BPC CENTRAL SEWERSHED PACKAGE 6 – CIPP PROJECT

Solicitation Number: CO-00479

Job No.: 20-4503

ADDENDUM 1

GENERAL NOTES SHEET 2 OF 2

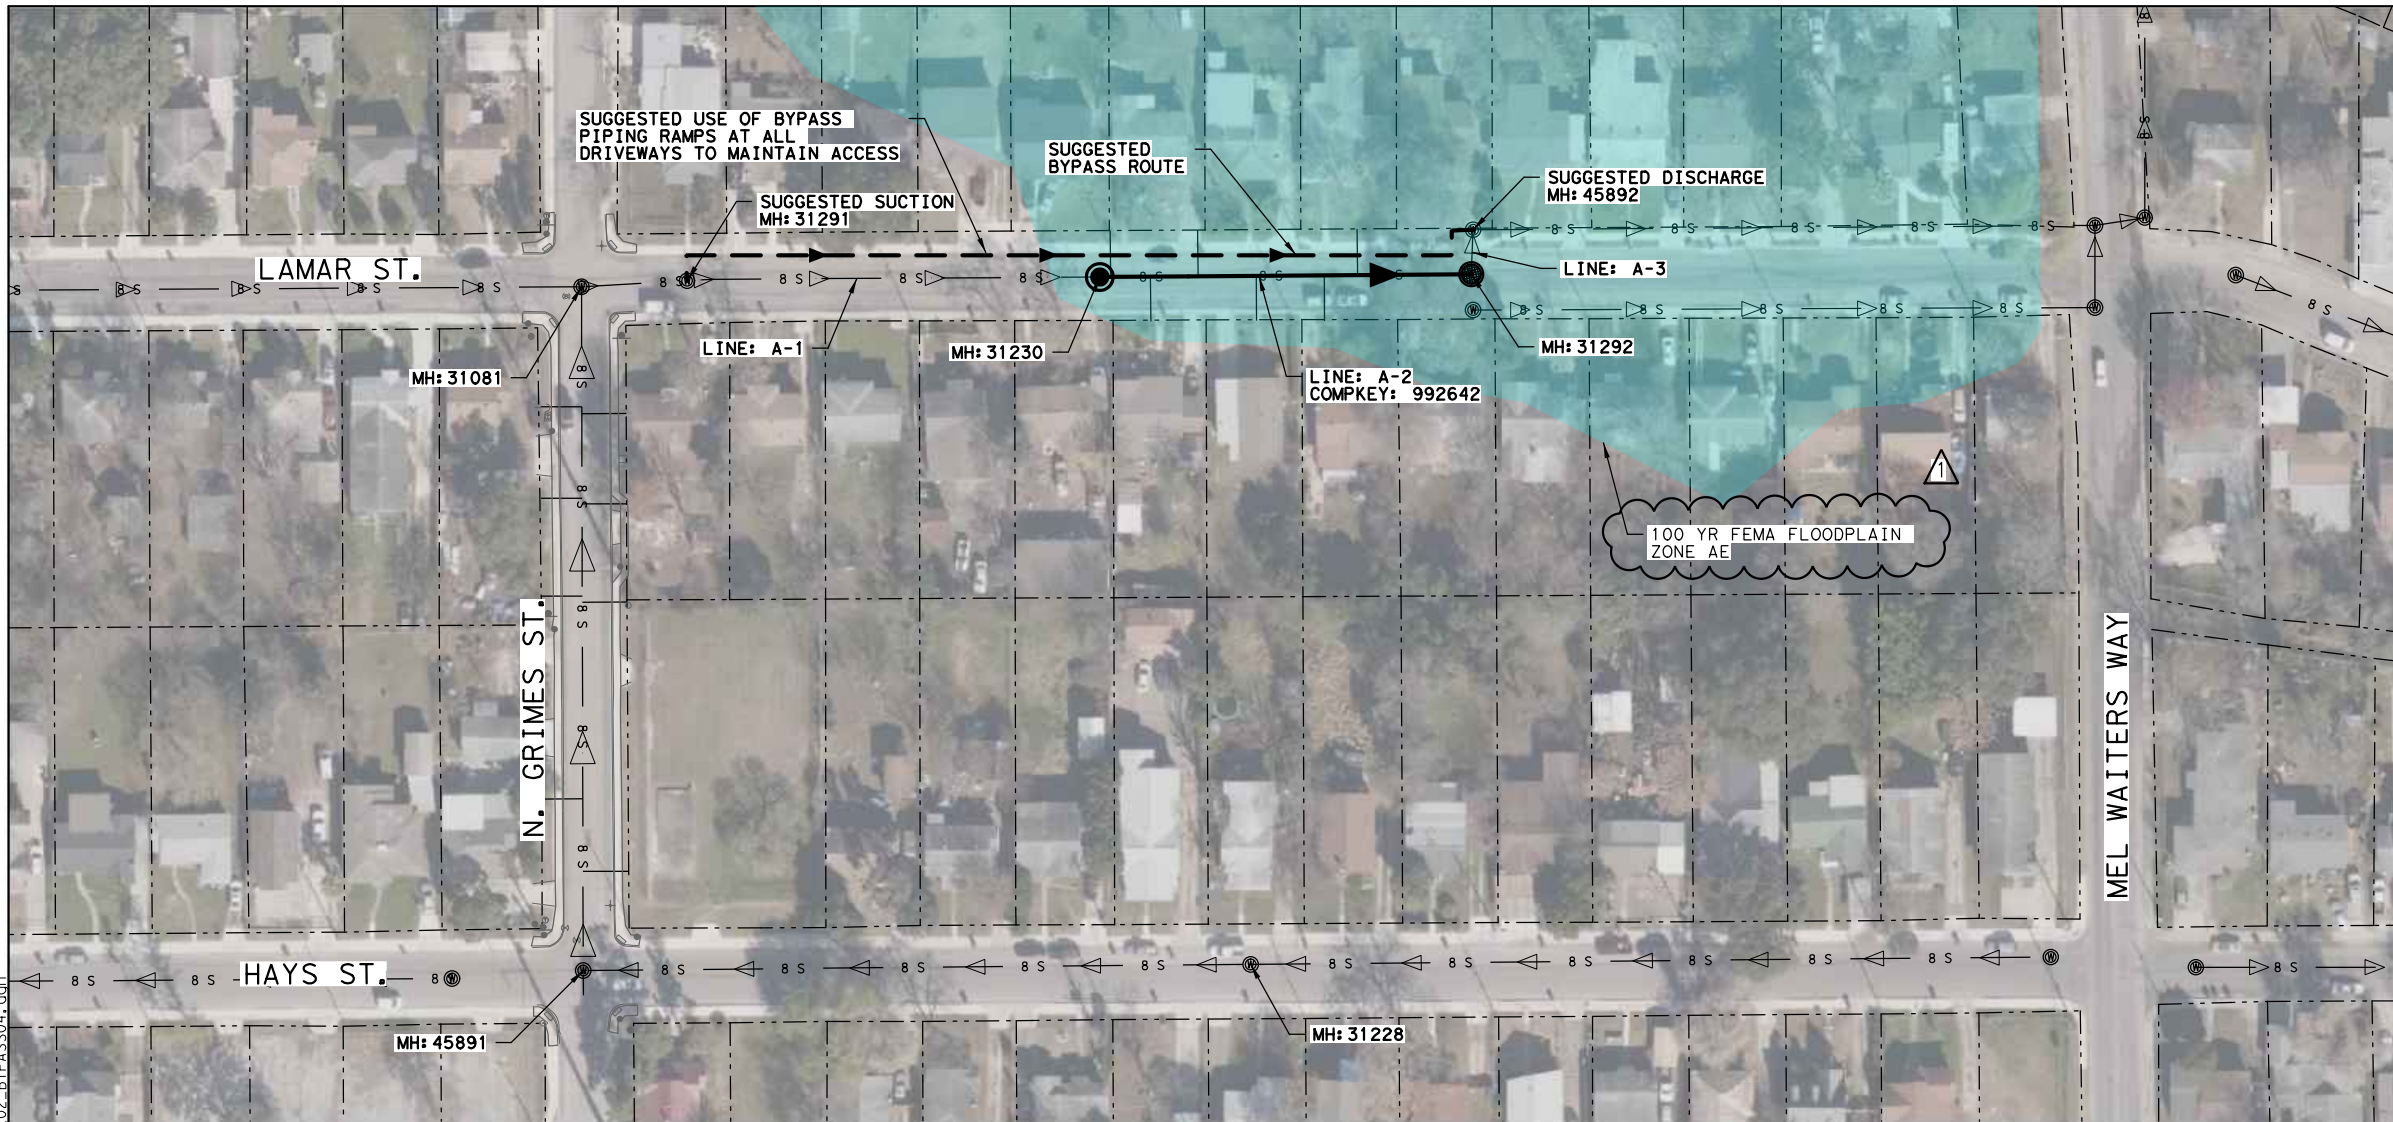
1. Page S129 is added to the plans with the page dated 8/27/2021 as this sheet was not uploaded with the original plan set.
2. Remove and replace Page S5 to the plans with the page dated 9/16/2021 as COSA floodplain notes have been added to the sheet.

NO	DATE	DESCRIPTION	DWG	CHK
Δ	9/16/21	ADDED FLOODPLAIN NOTES

**SITE 5
COMPKEY 992642
SUGGESTED SANITARY SEWER
BYPASS LAYOUT**

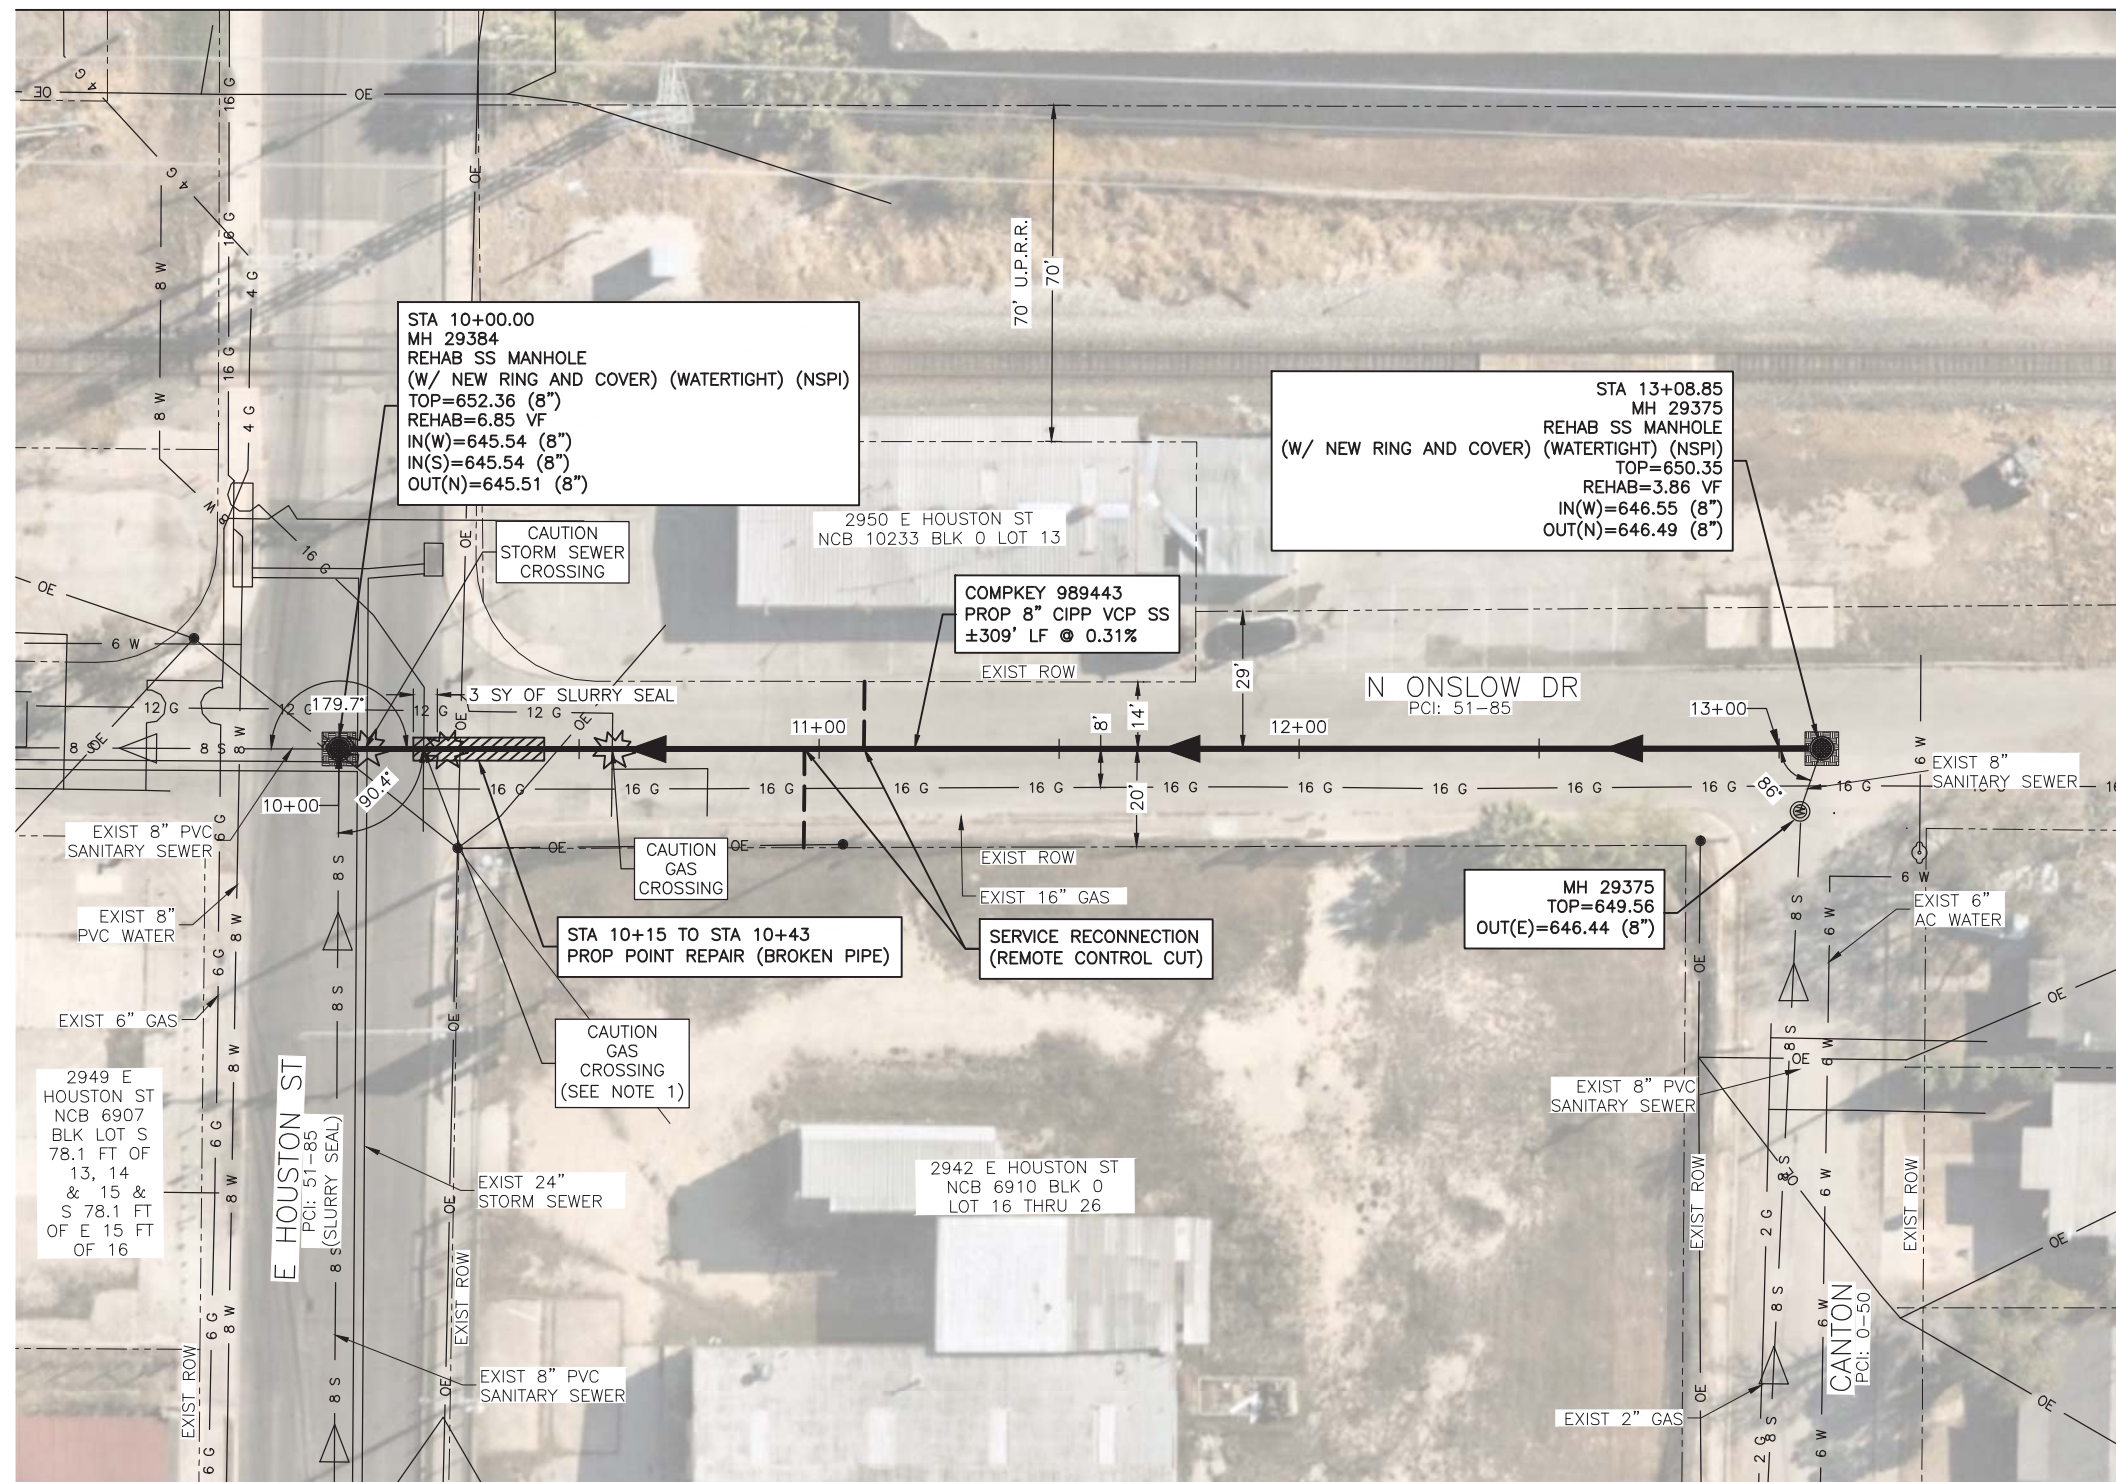
3. Remove and replace Page S28 to the plans with the page dated 9/16/2021 as the 100-year floodplain has been added to the sheet.
4. Remove and replace Page S51 to the plans with the page dated 9/19/2021 as Note 3 regarding excavated soils has been added to the sheet.

NO	DATE	DESCRIPTION	DWG	CHK
Δ	9/16/21	ADDED FLOODPLAIN

SITE 7
COMPKEY: 989443
SEWER PLAN
STA 10+00.00 TO END

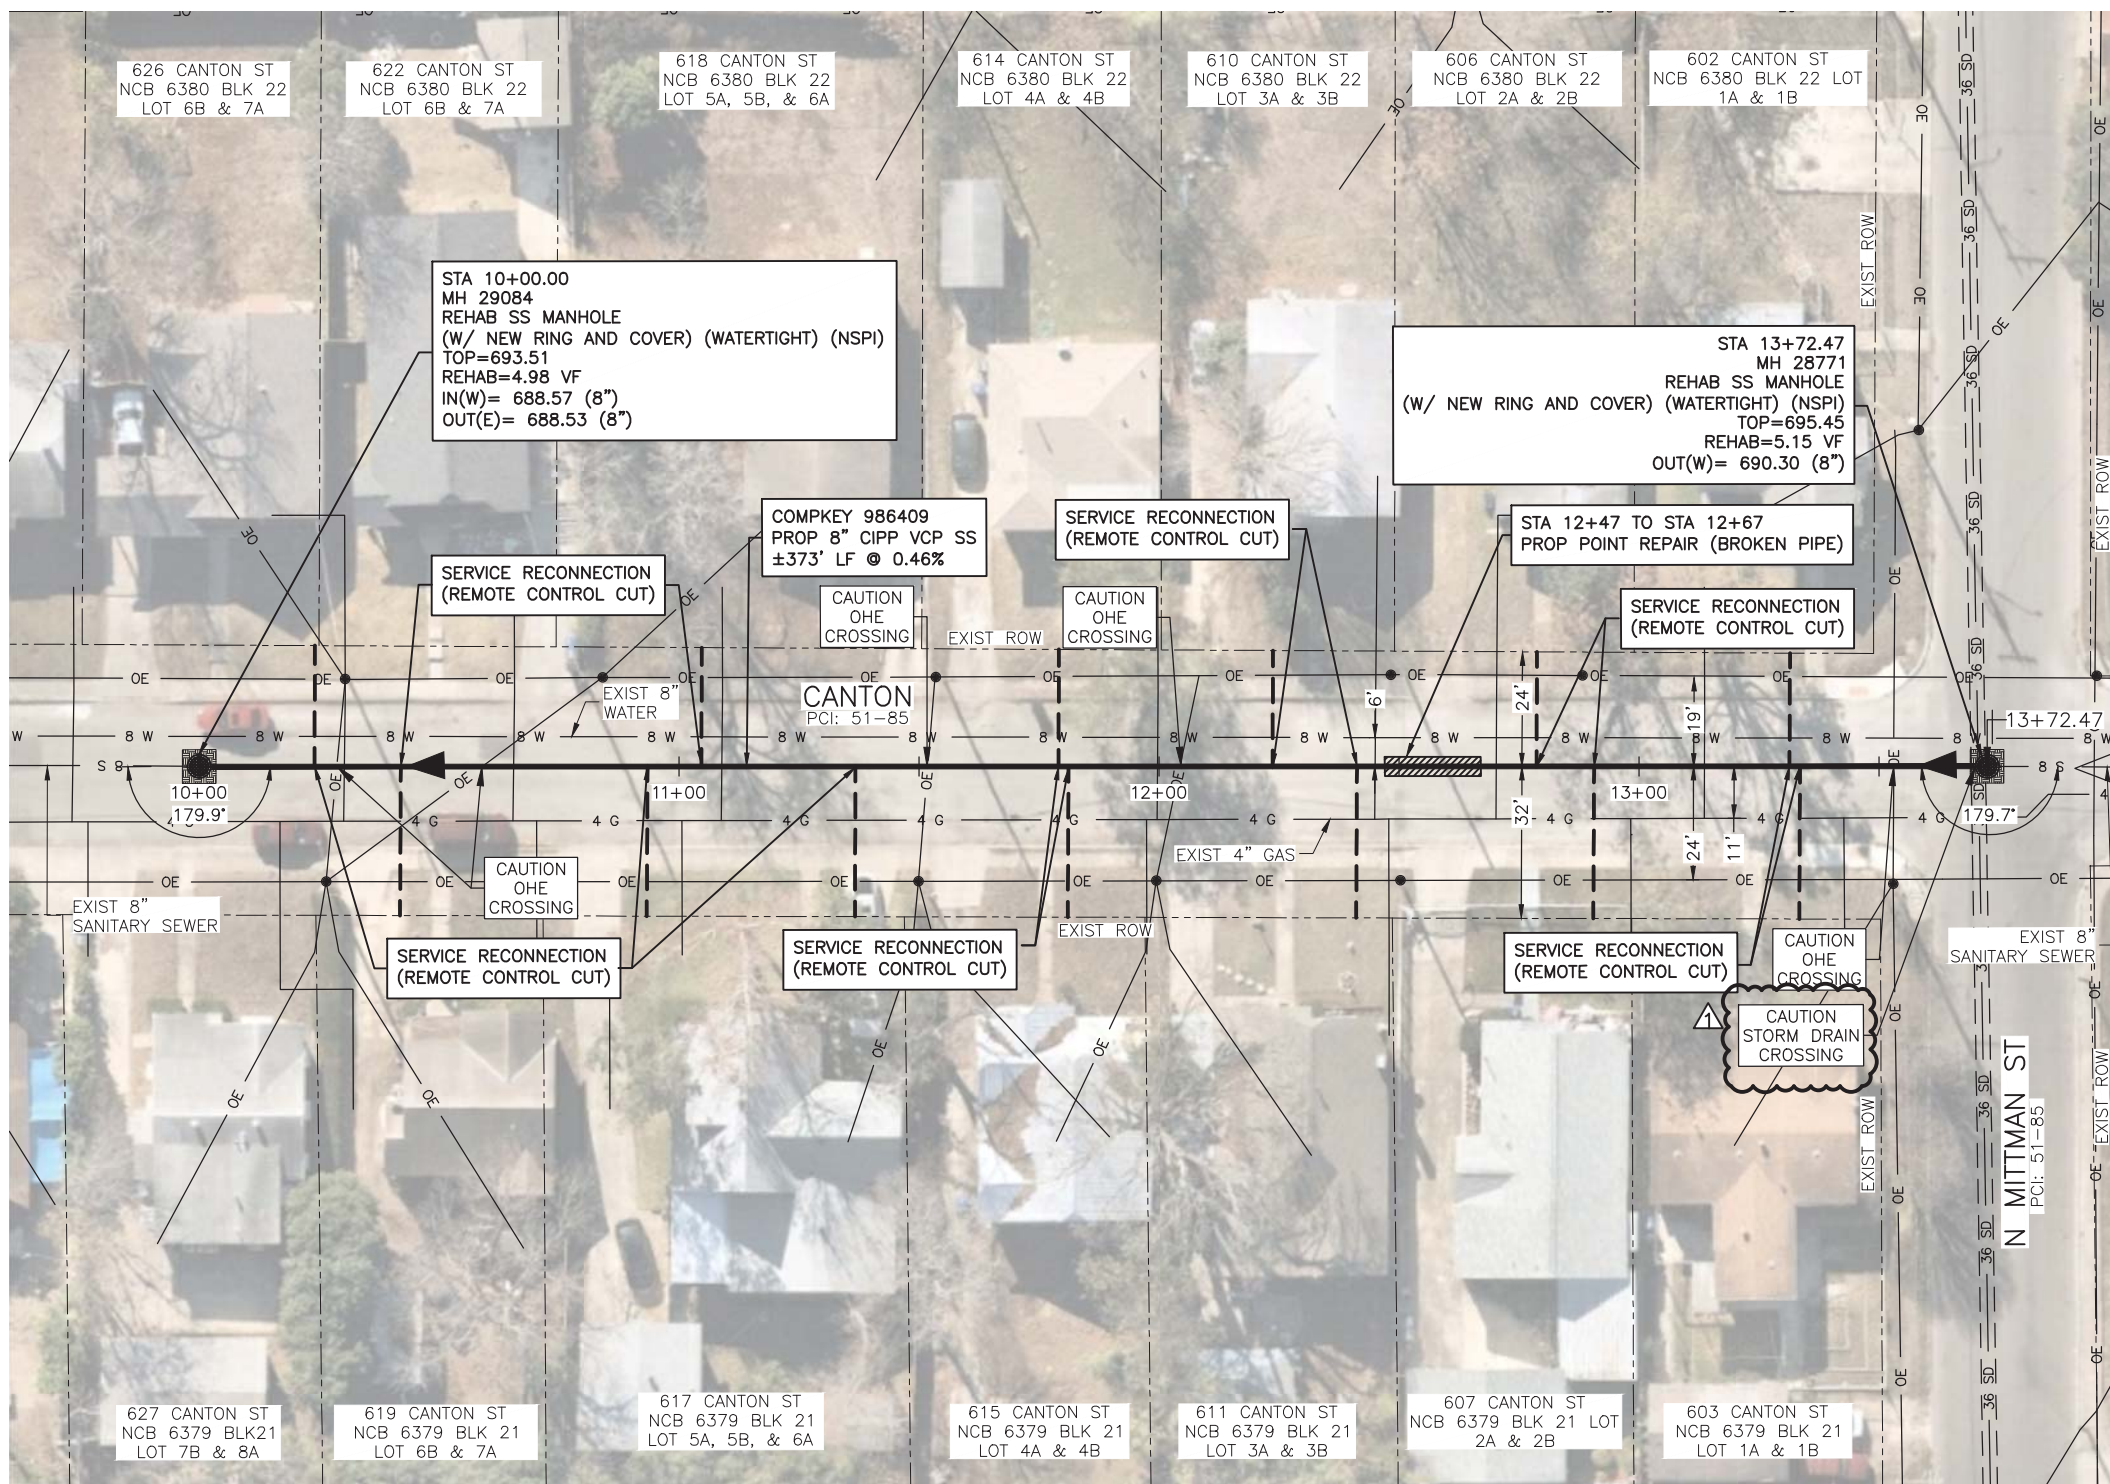
NO	DATE	DESCRIPTION	DWG	CHK
1	9/17/2021	ADDED SOIL EXCAVATION NOTE	LG	JAS

- ALL EXCAVATED SOIL SHALL BE USED ON SITE AS BACKFILL AND NO SOIL SHOULD BE HAULED OFF FROM THE SITE DUE TO POTENTIAL CONTAMINATION (NSPI). IF SOIL NEEDS TO BE HAULED OFF, THE CONTRACTOR SHALL HAVE THE SOIL TESTED AND DISPOSED OF PROPERLY AT A LICENSED LANDFILL (NSPI).
